H22-19
Hotel Redevelopment
REVISED

Property Owner: Legacy Hotel of Medina LLC
Applicant: Jim Gerspacher
Location: 253 and 257 South Court Street
Zoning: C-2 (Central Business)
Request: Certificate of Appropriateness revisions for the construction of a hotel

The current application revises the footprint and height of the hotel building, updates building elevations, and provides greater detail. The proposed revision does not alter the previous approval regarding the demolition of two existing buildings at 253 and 257 South Court Street or application H24-06.

This letter is regarding the proposed hotel on parcel 028-19A-21-397. Our team has been working on adjustments to the overall building design to improve constructability, enhance the floor plans for both operational efficiency and guest experience, as well as enhance the exterior design and compatibility within the Historic District.

LANDSCAPE SITE PLAN
SCALE = 1" : 20'
NOTE: NOT A SURVEY. ALL DIMENSIONS TO BE VERIFIED IN-FIELD

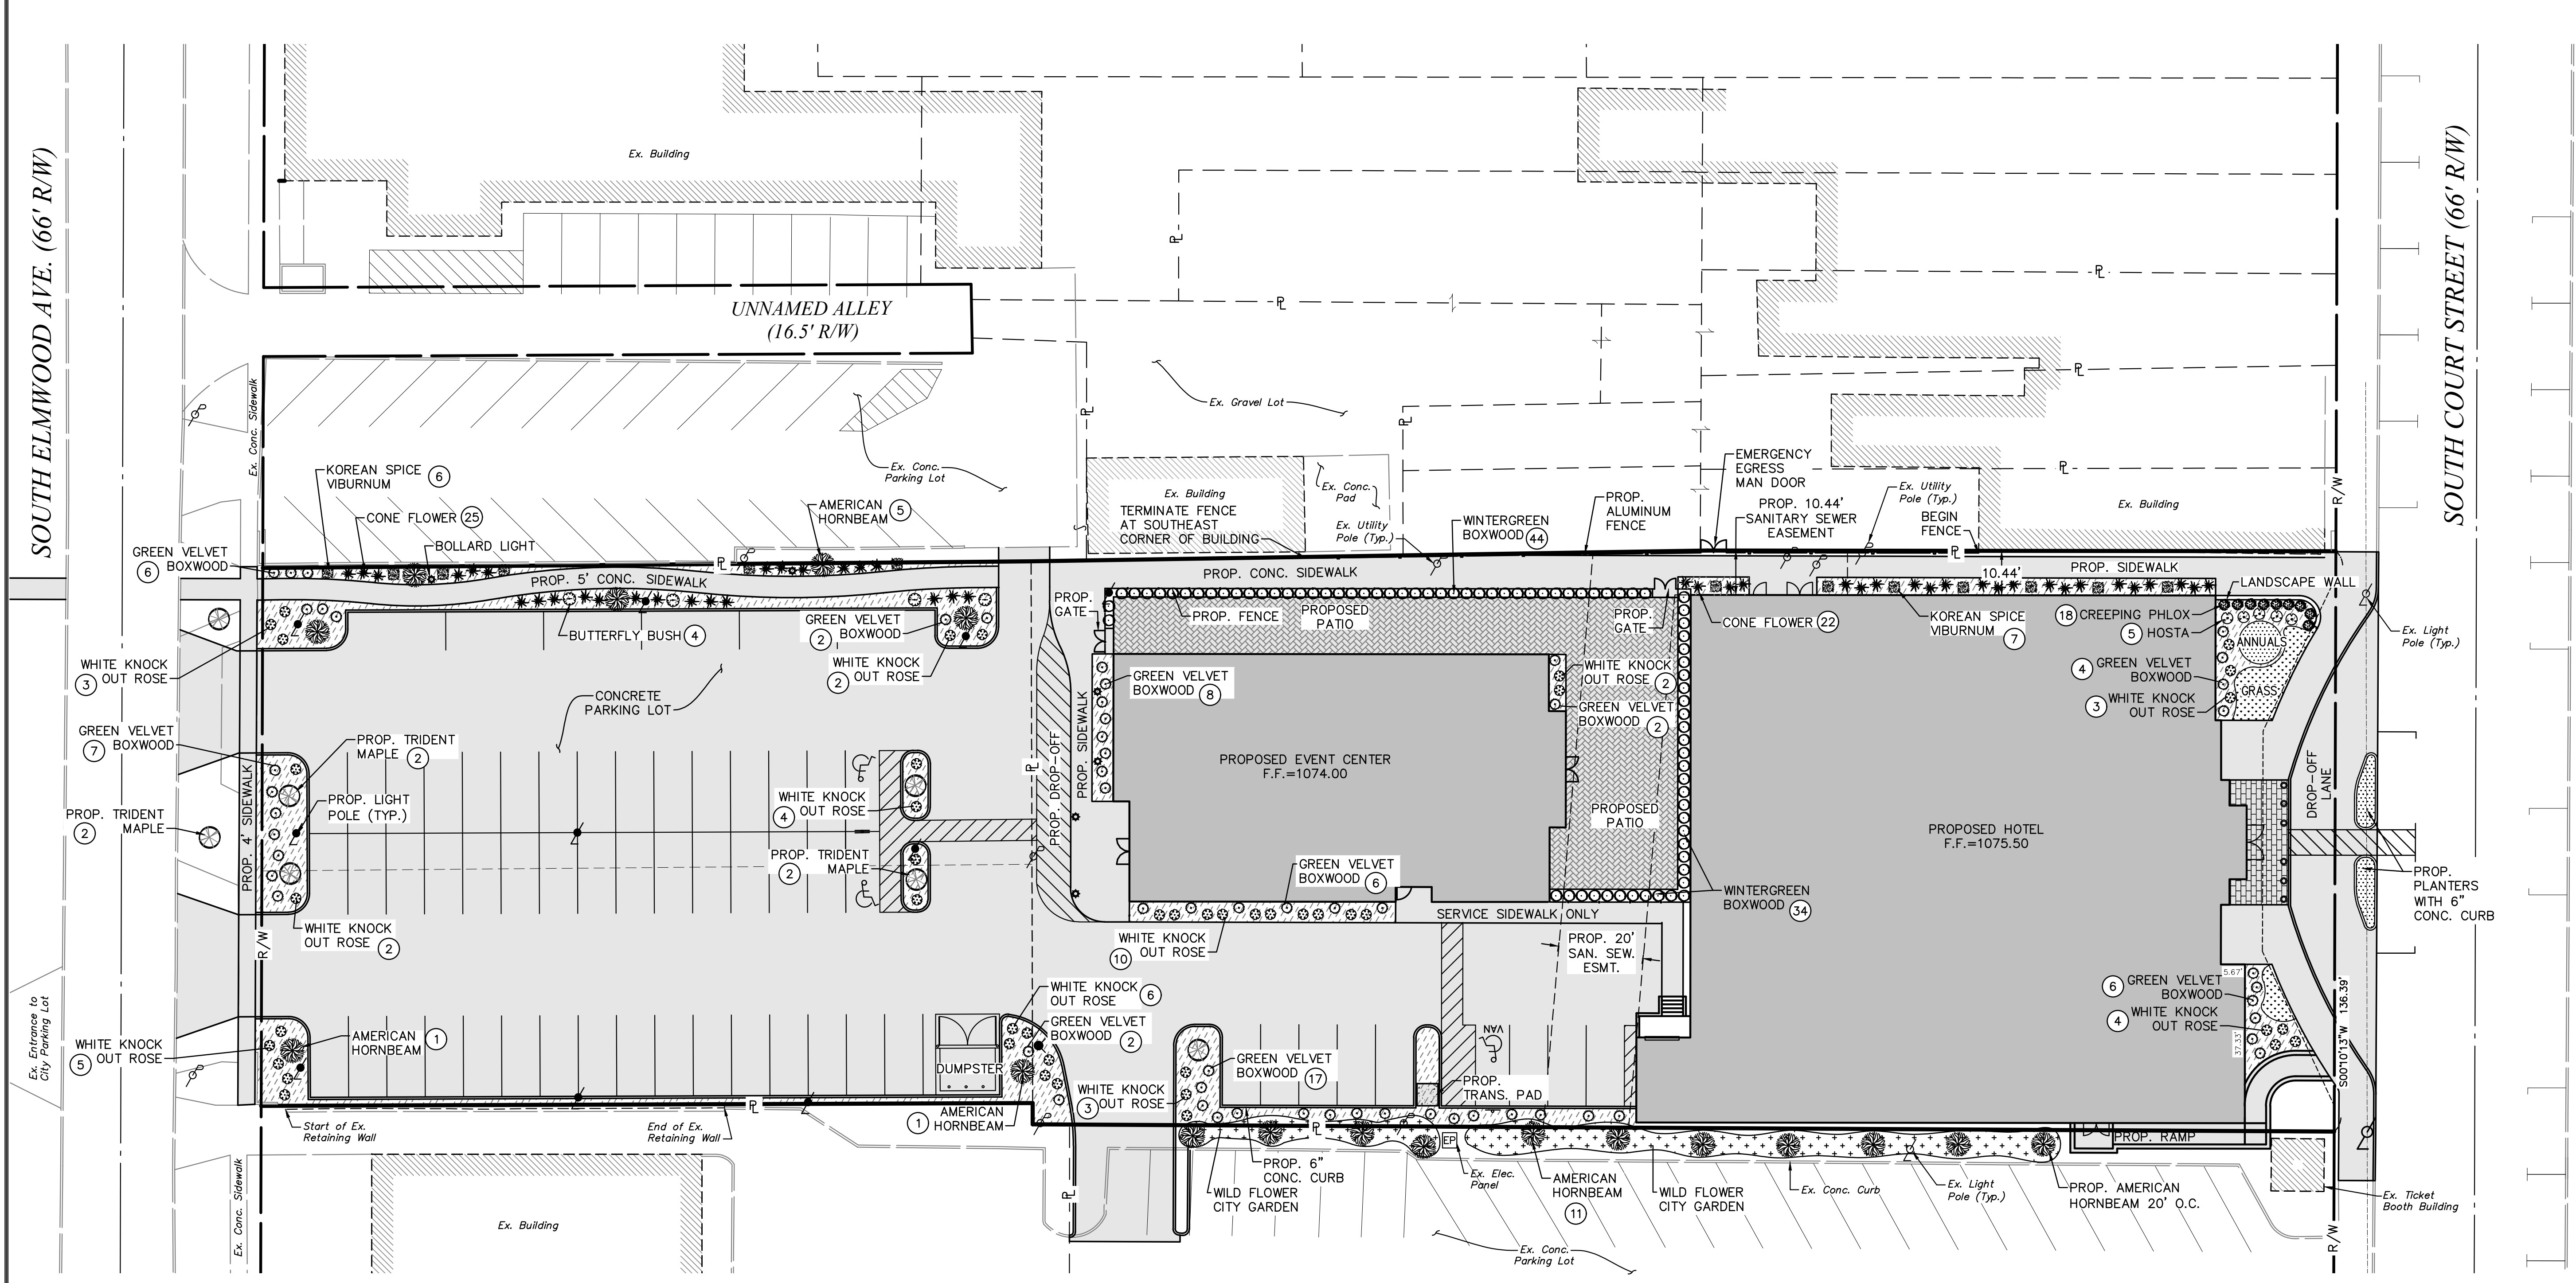
The landscaping plan has been revised slightly to include landscaping on the north side of the hotel.

PRELIMINARY SITE PLAN

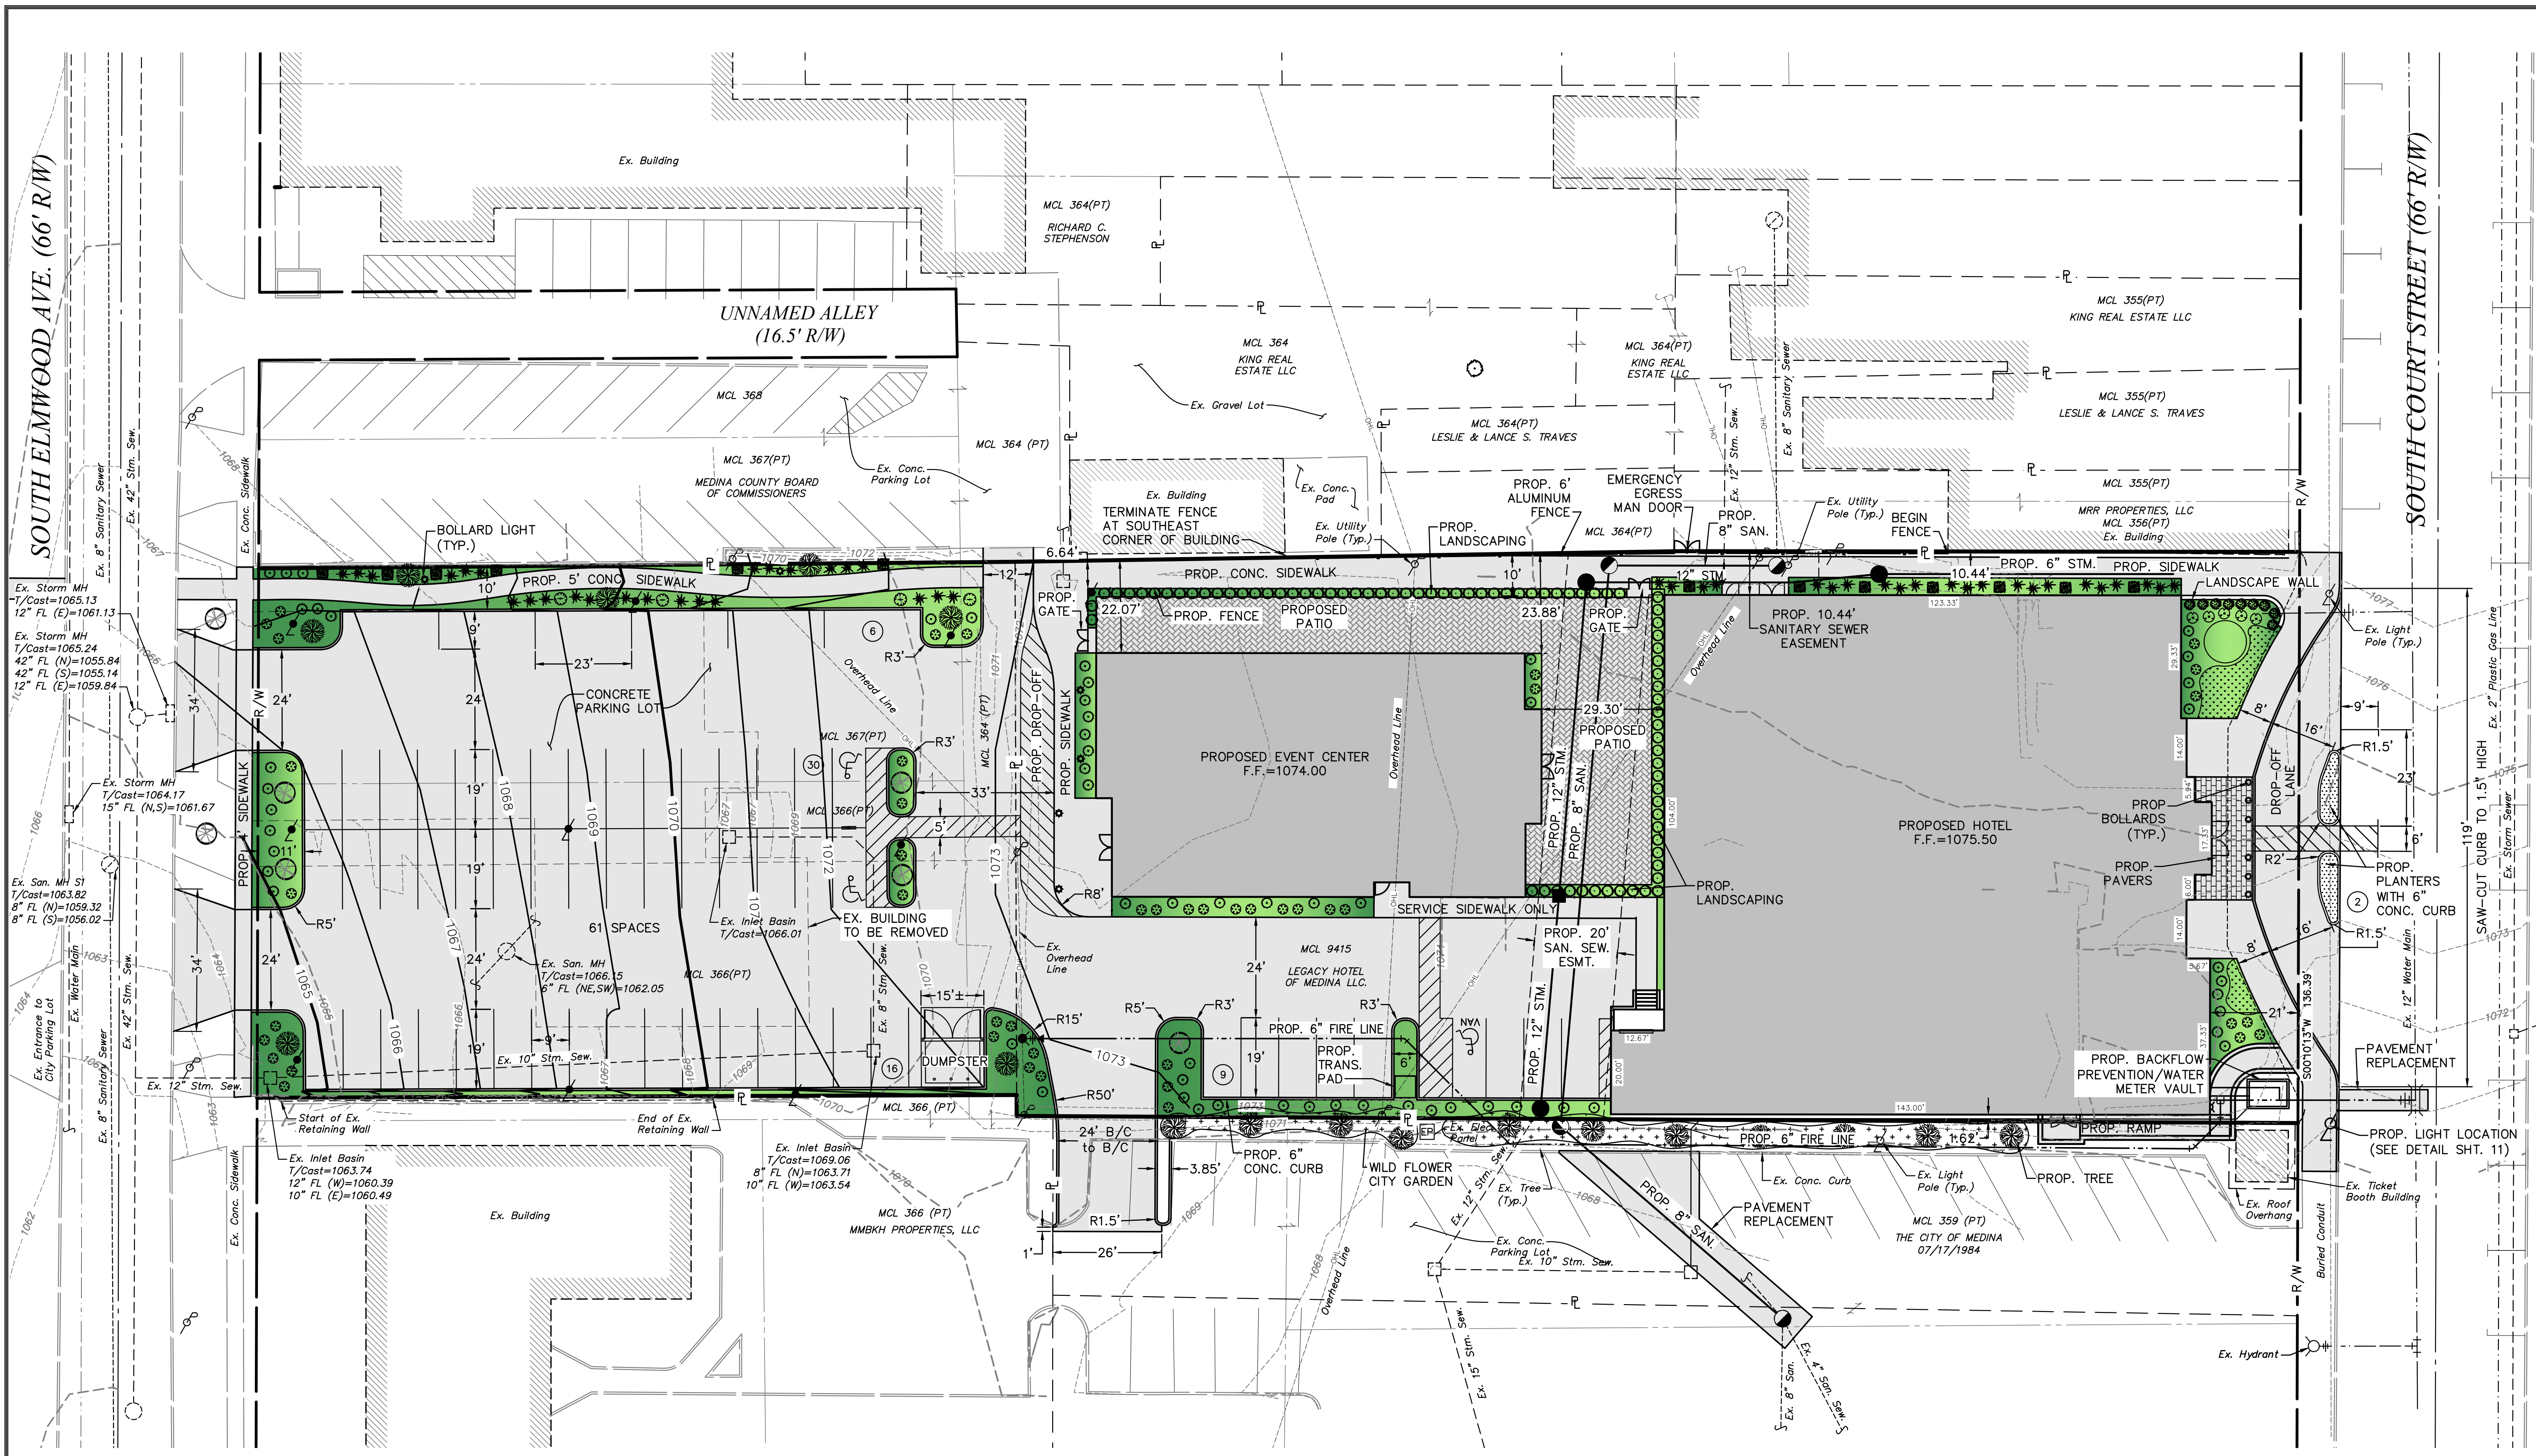
The previous approval included a hotel located on the east side of the site, a one-way drop off lane adjacent to South Court Street, and a rear parking lot. The revised site plan incorporates a hotel and restaurant/bar, shifts the building 3 ft. further from the right-of-way, and enlarges the building footprint, as follows:

The previously approved building contained an open courtyard in the center of the entire building. The proposed building's footprint has increased due to the removal of the courtyard on the first floor and modifications to the east and west sides of the building. The open courtyard remains on all other floors of the building and the width of the building adjacent to South Court Street remains unchanged.

1 PLAN PRELIMINARY SITE PLAN - HOTEL
 1" = 40'-0"

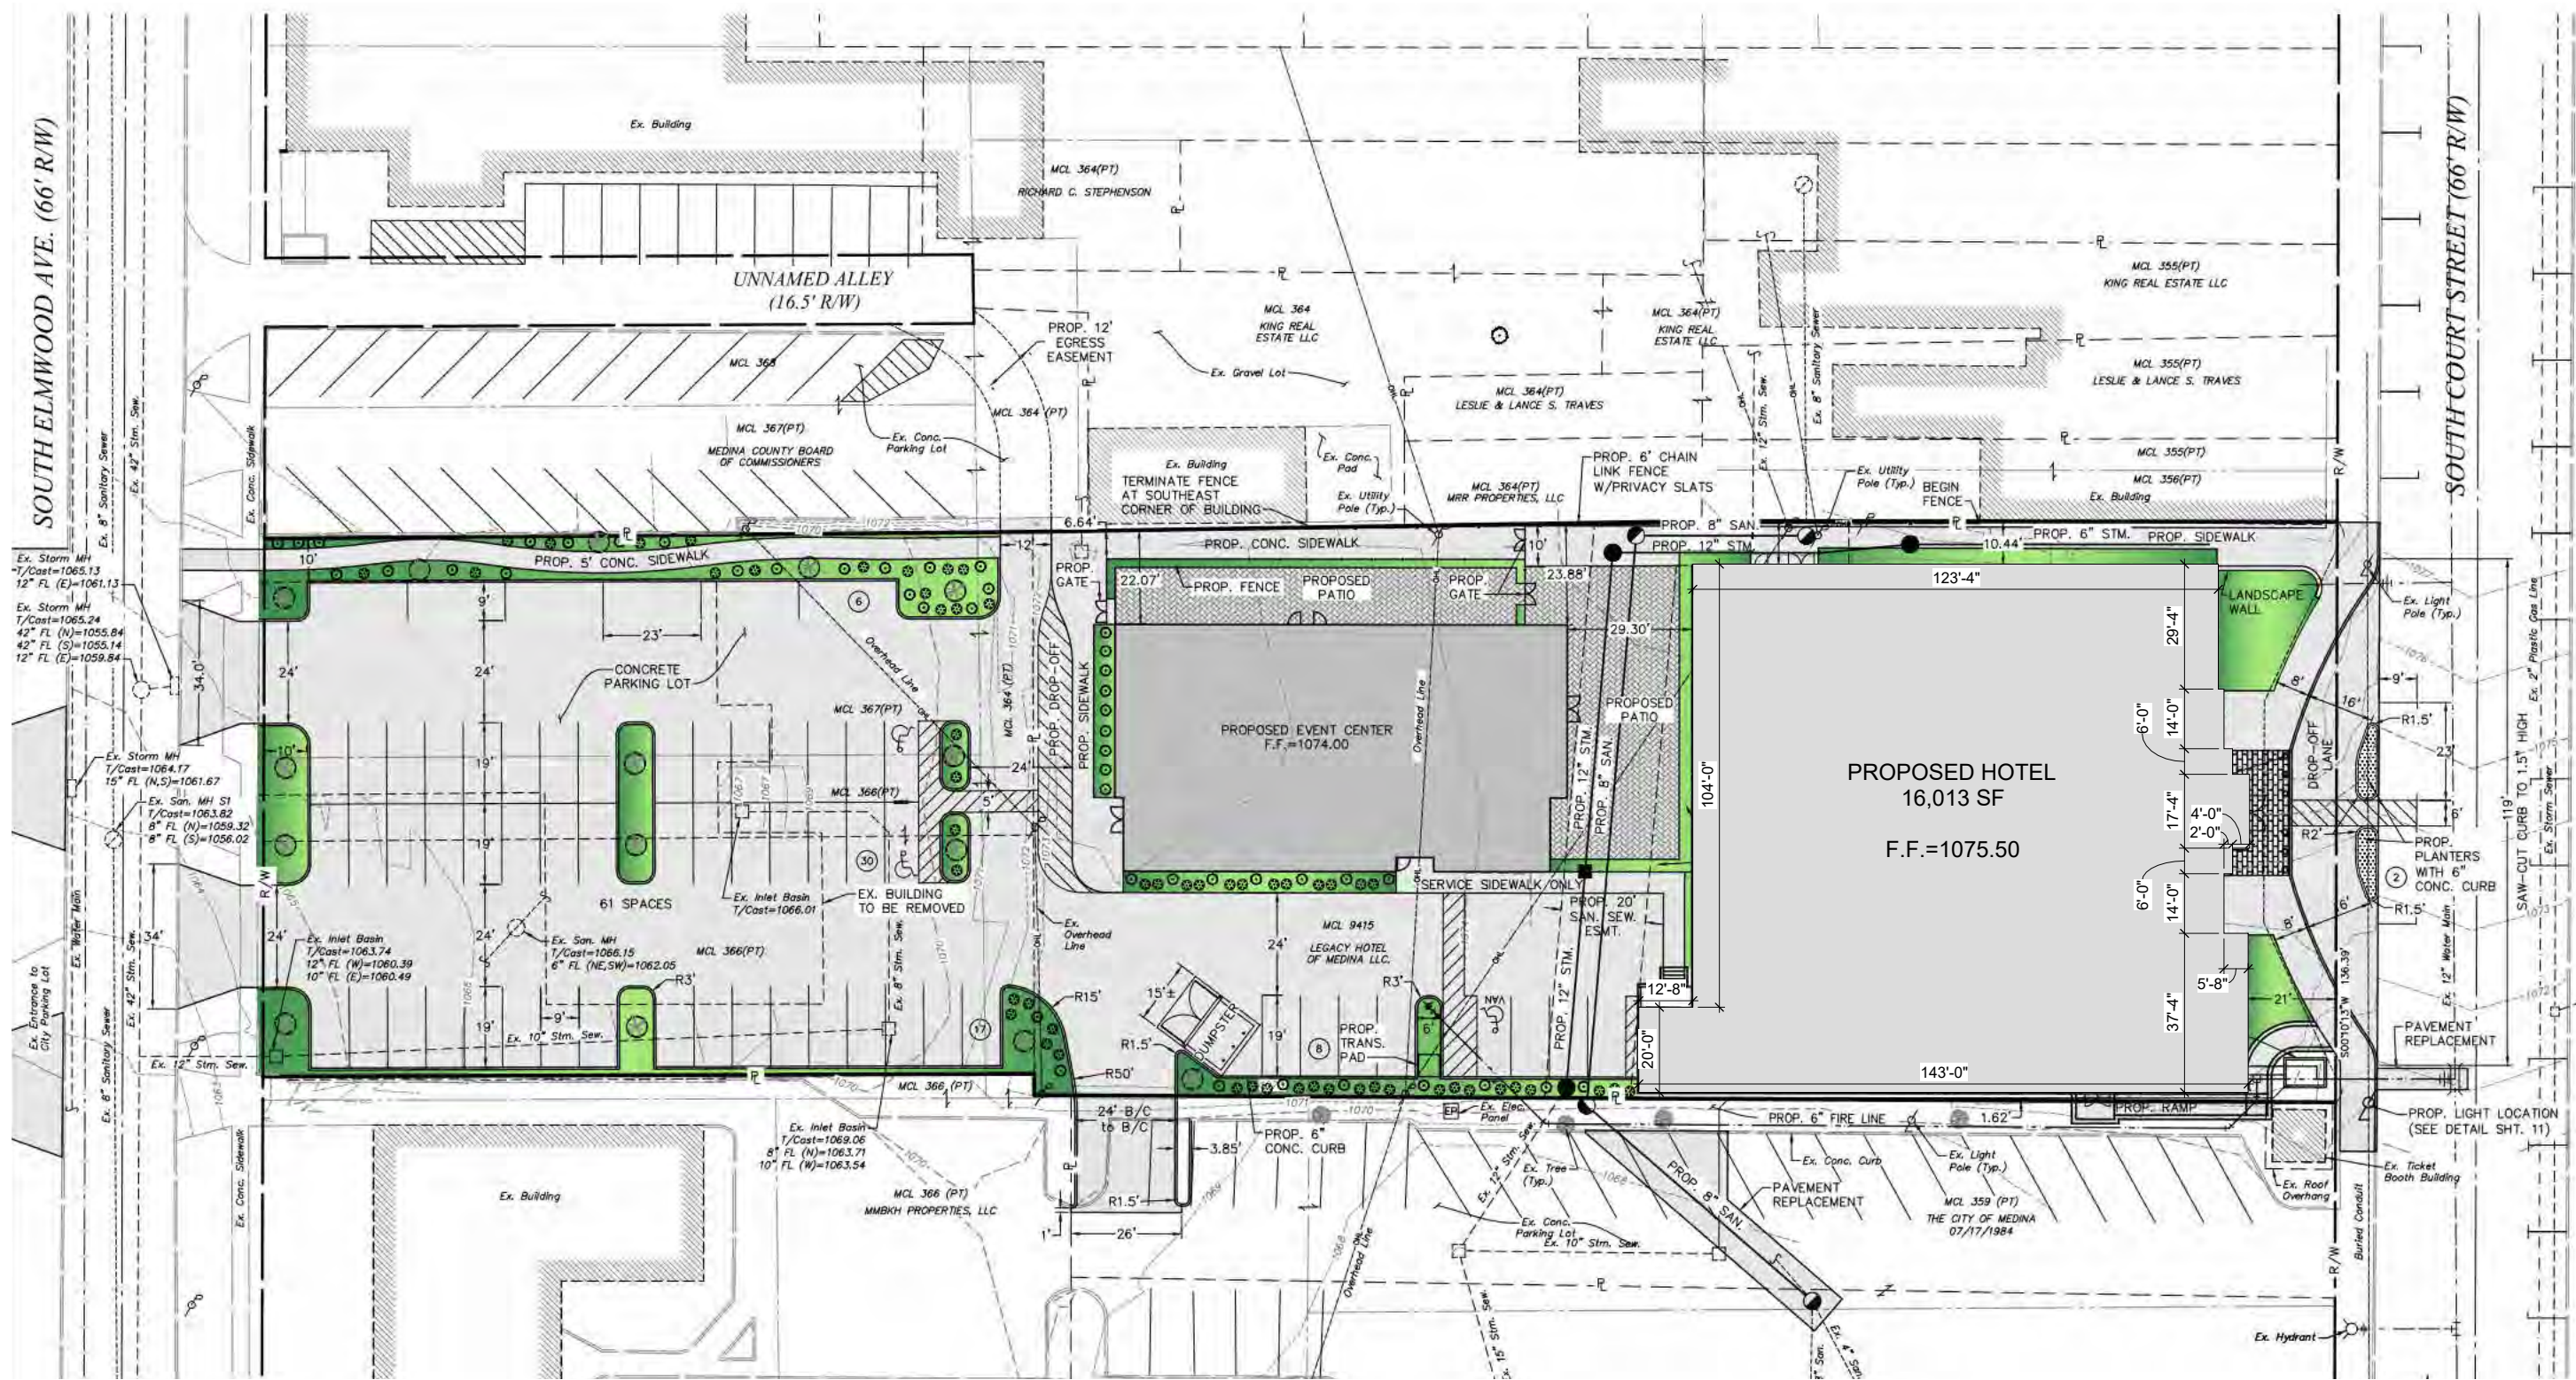
- 1- Footprint increase of 3,229 sf: Previously approved footprint was approximately 12,784 sf and proposed is 16,013 sf.

While there are minor changes to the perimeter dimensions, the square footage increase is largely due to the infill of the courtyard on the first floor. The courtyard remains a feature in the project accessed by guests on the second floor. The exterior perimeter of the hotel has grown negligibly, and it would be nearly impossible for someone to see that increase from outside the hotel. Please see below a snippet showing both footprints overlapped (blue is original footprint – gray is updated)

- 3- Setback increase from 18ft to 21ft: the building was pushed back a few feet to allow more space between the hotel and the existing southeast building, accommodating the new accessible ramp on the southeast corner. We believe that the dimension increase will also help reduce the perceived height of the building.
